Model 200/8 to 250 E/8

Following the installation of the manual transmission G 76 and the automatic transmission with three-planetary gear set the following changes were made on intermediate flange:

Fig. 01-8/1
New version

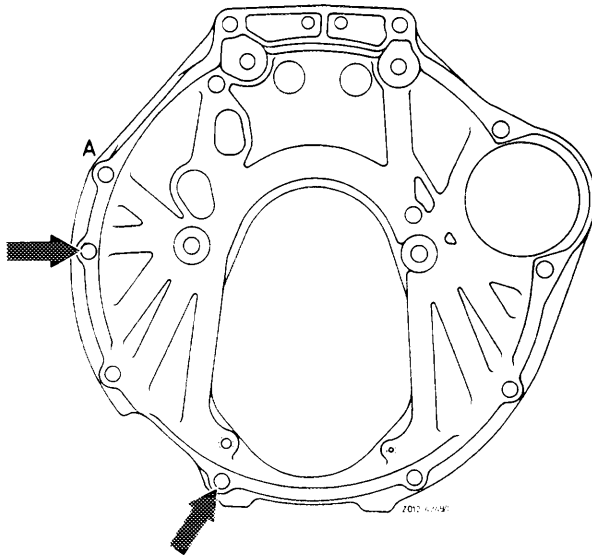
The new intermediate flange is provided with an additional hole for attaching the clutch housing (refer to arrow in Fig. 01-8/1). Bore "A" is not used on these transmissions.

The hole pattern of the remaining holes has not been changed.
The new transmissions may be assembled only with the new intermediate flange.
